Burlington Design Advisory Board

DESIGN ADVISORY BOARD Tuesday, March 28, 2017 at 3:00 PM Conference Room 12, City Hall, Burlington, VT Agenda

TO: Design Advisory Board
FROM: Ryan Morrison
DATE: March 28, 2017
RE: 17-0838CA, 76 King Street

Request: Replace asphalt shingle roof with a black, metal standing seam roof.

BLED5-36Y

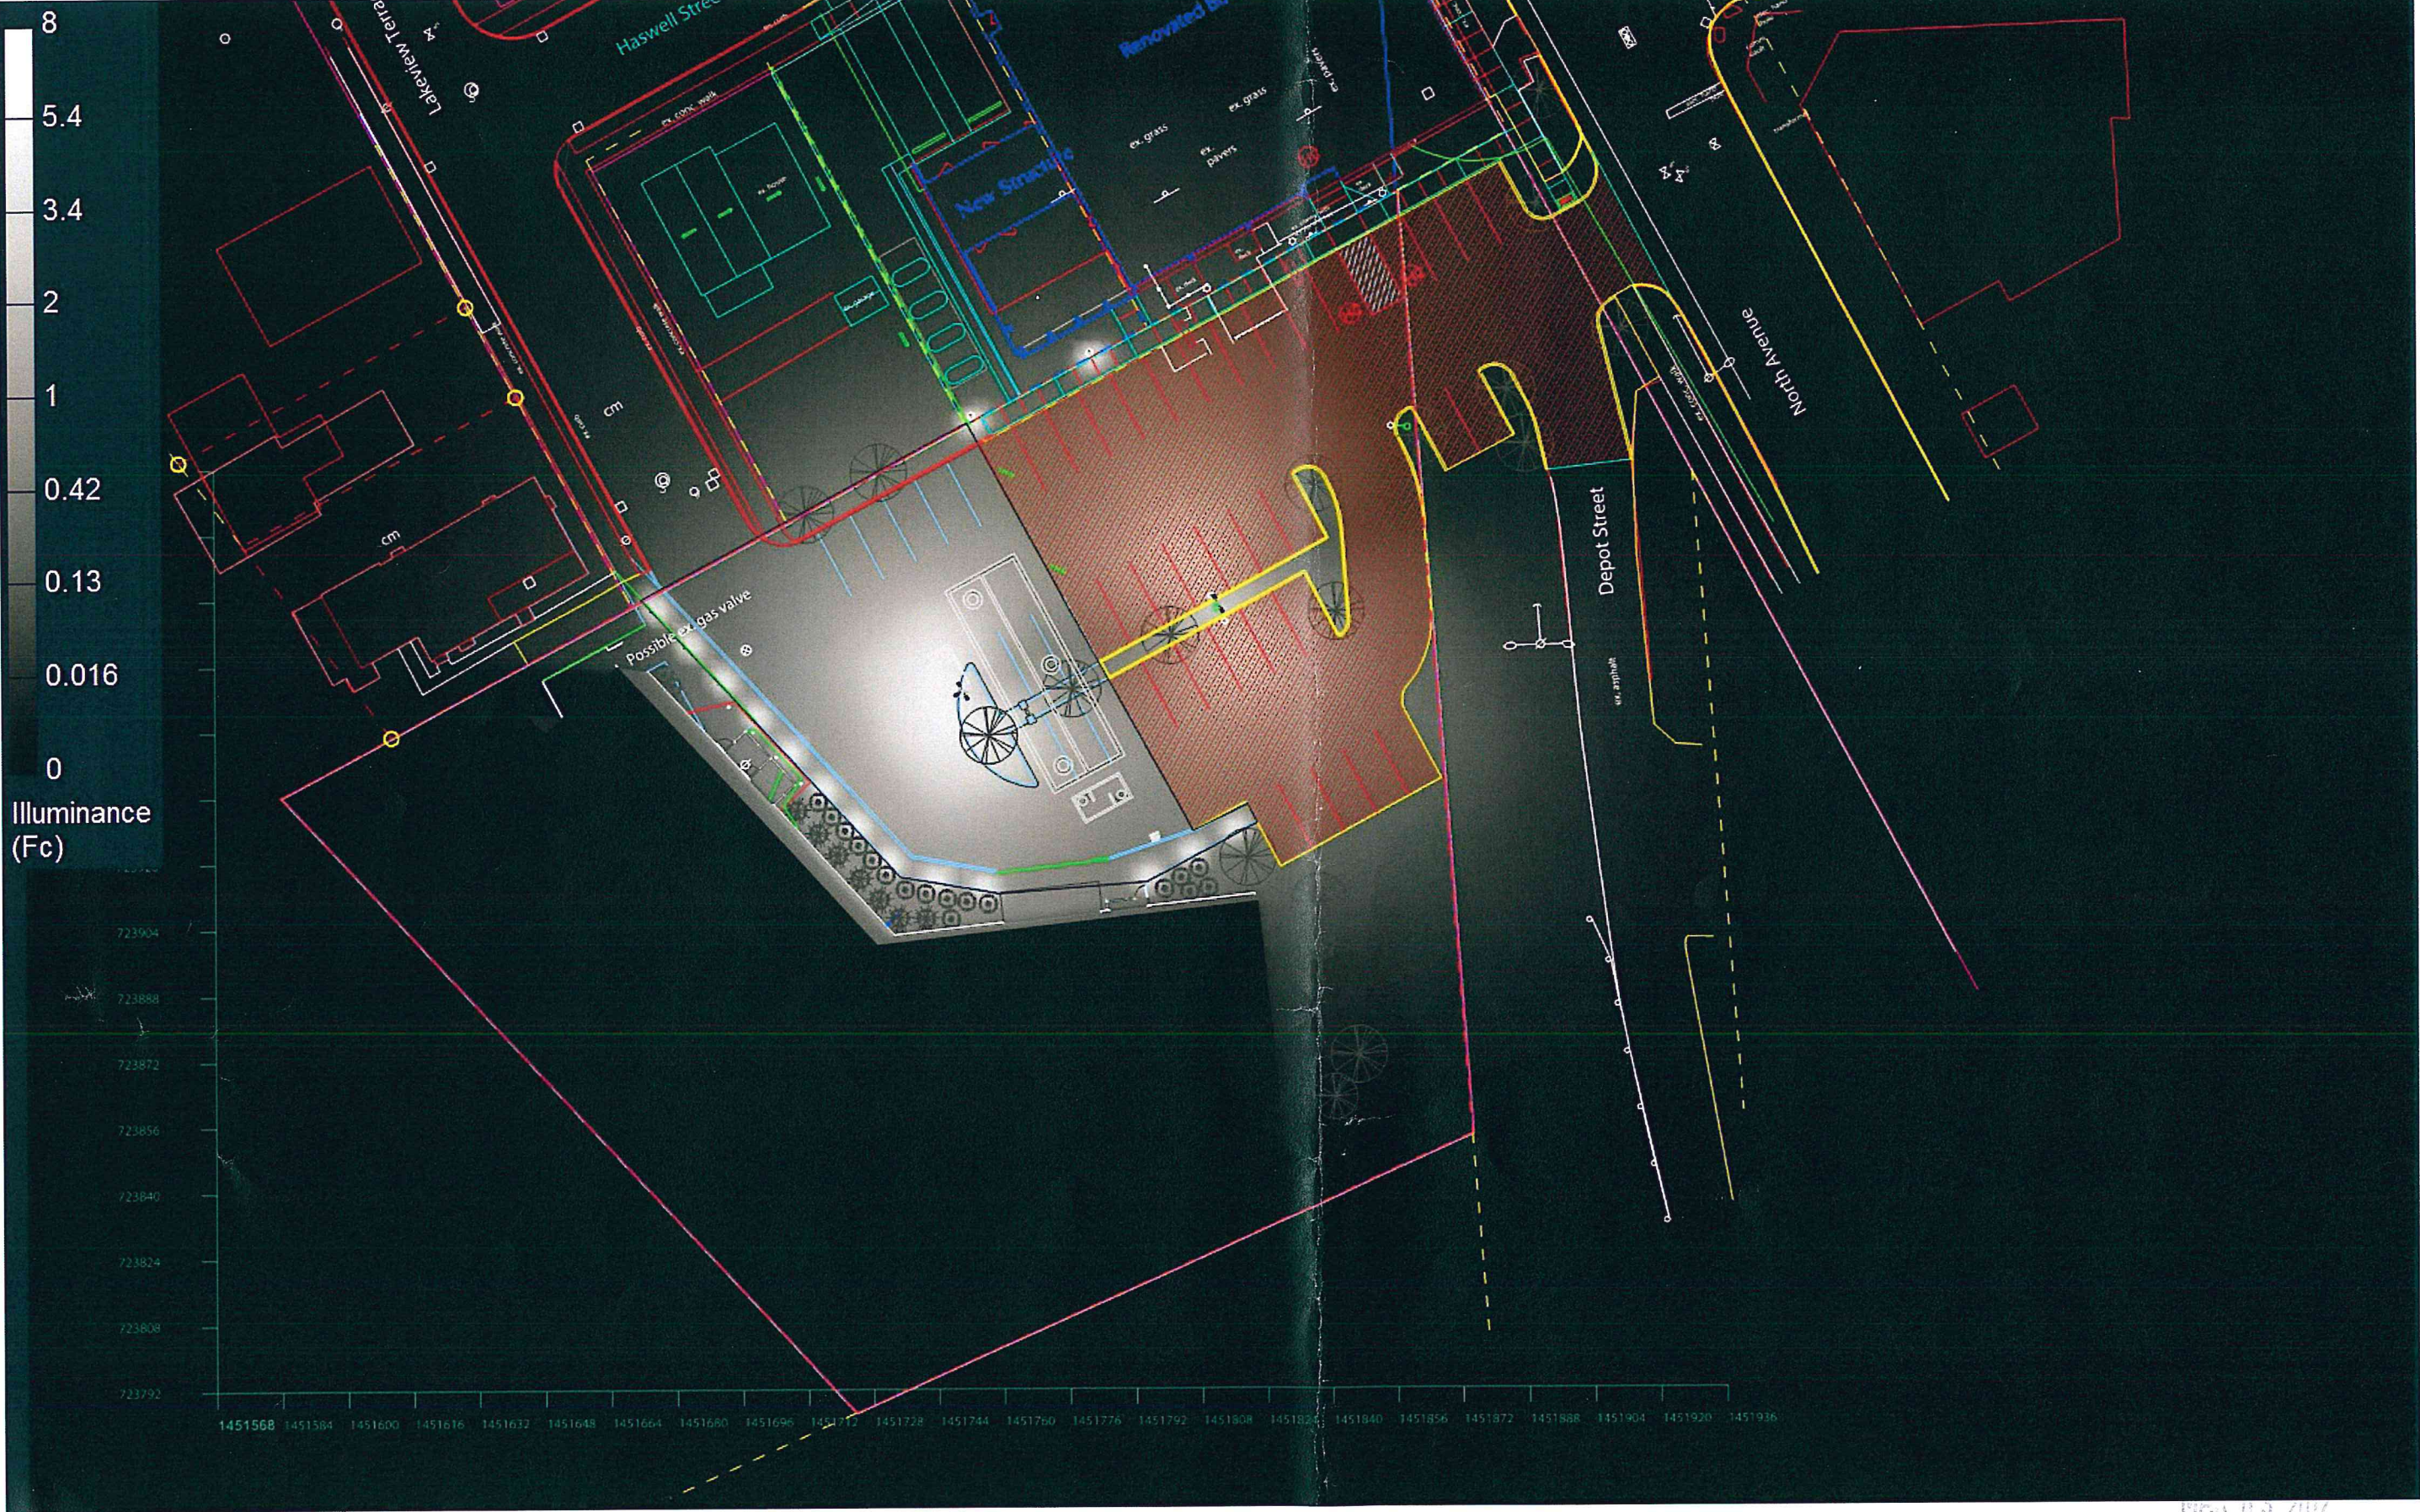
Outdoor lighting information has been provided, including a photometric plan and a fixture cutsheet for the surface parking area. The specified fixture is acceptable – a cutoff LED luminaire. Illumination levels; however, are too bright in places. There are several hot spots exceeding the 4.0 footcandle limit for surface parking areas. Lamp mounting height is acceptable at 20.'

VIEW FROM LAKEVIEW TERRACE

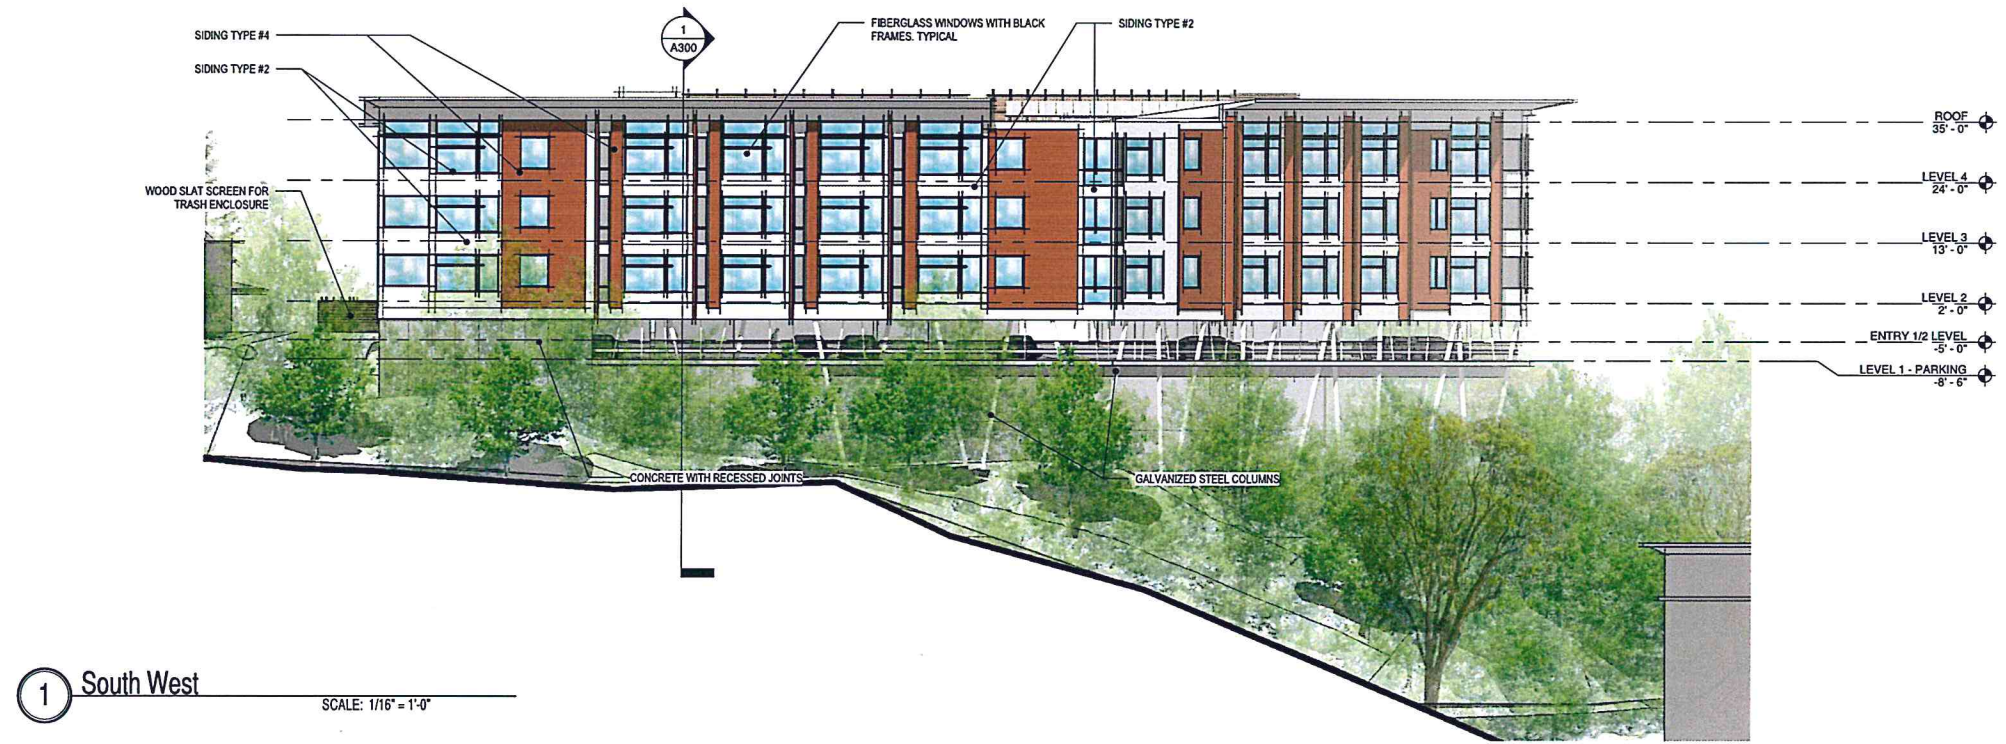
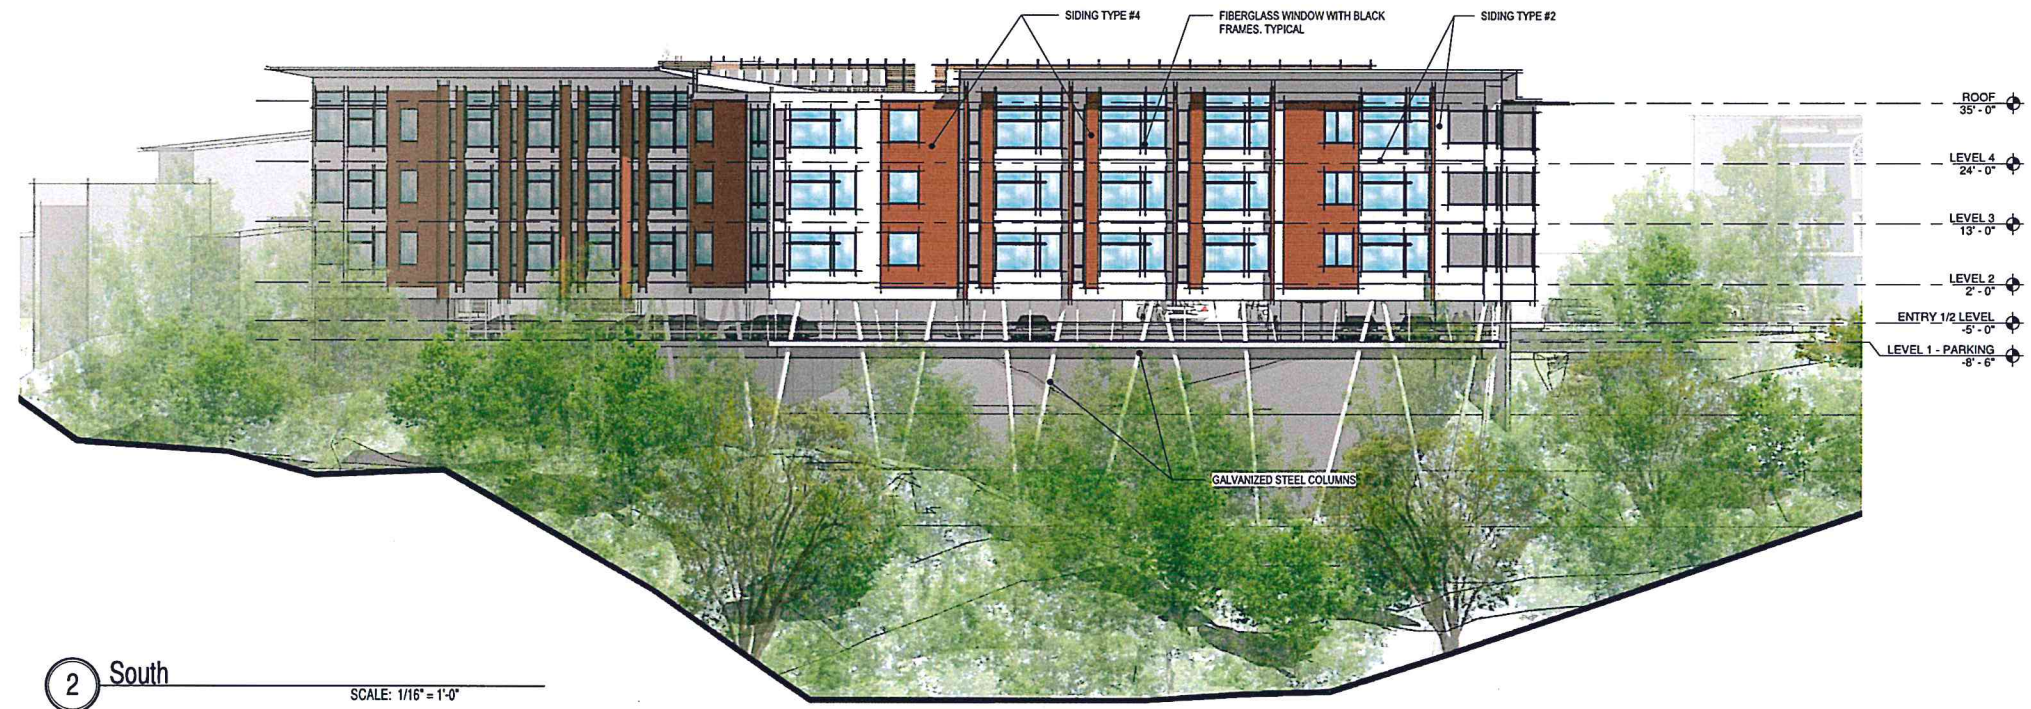
Enclosed are revised perspective & elevation drawings of 85 NA. I realize board packets have already gone out to DAB members, but if these more current versions could be switched out that would be much appreciated. I intend to present these images at next week’s hearing.
